PORTLAND PARKS & RECREATION
Healthy Parks, Healthy Portland

North Portland Aquatic Center: Phase 2 / Cycle
Executive Summary – August 2025

Meet Me at Geneva

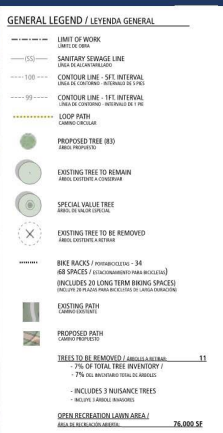
- This design features two parking entrances on Geneva which would reduce traffic congestion and safety issues on busy Fessenden Street.

- The parking lot access on Geneva would be too impactful to neighbors on a narrow street.
- The entrance to the building felt like a long distance from the parking lot and was not as visible as the other two options.
- The pavilion location in the northeast corner of the park would be hard to access to unload equipment for an event and might be a draw for negative behavior, especially late at night.

Beacon in the Park

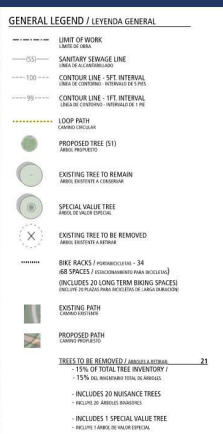
- Strong visual presence with striking glass corner features and view of the pool and building from Fessenden Street would create a landmark and invite people into the pools.

- Preserves park amenities and character, by providing the most greenspace to accommodate a full-sized soccer field and maintains the tennis courts (the only option not proposing to convert the courts to a small parking lot).
- While it does impact trees, 20 of the 21 trees are Norway maples, which is a nuisance species as defined by City of Portland Title 11 code. New trees in accordance with Title 11 and in support of Urban Forestry tree canopy goals will be planted as part of the project.

- Impacts largest number of trees.
- Pavilion location may be too close to the building.
- Those who preferred Meet Me at the Geneva were concerned about impact of having the parking lot accessed from Fessenden Street.
